NEI 99-02 FAQ 20-05  
RBS Unplanned Scram May 2019 – Proposed NRC Response

Plant: River Bend Station, Unit 1  
Date of Event: 5/31/2019  
Submittal Date: October 09, 2020  
Licensee contact: Timothy Schenk Tel/email: 225-381-4177 / tschenk@entergy.com  
NRC Contact: Raymond Kumana Tel/email: 817-200-1970 / rkuma94@entergy.com

Performance Indicator: IE04 - Unplanned Scrams with Complications (USwC)

IE04 Unplanned Scrams with Complications – Flowchart  
Figure 2

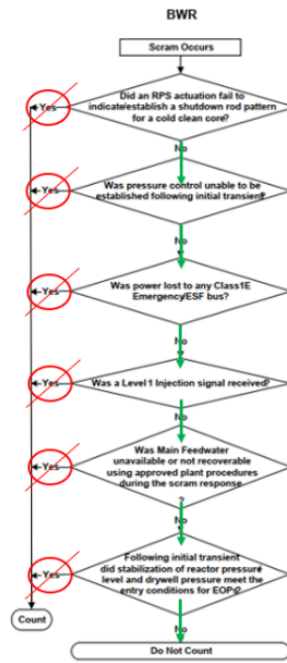
Based upon the above timeline and NEI 99-02 Rev. 7 definitions, RBS was outside the "Scram Response Time" by 30 minutes before the subsequent level three scram signal and therefore did not have an Unplanned Scram with Complications. Additionally, the below flowchart demonstrates this conclusion as seen in NEI 99-02 Rev.7, Figure 2.
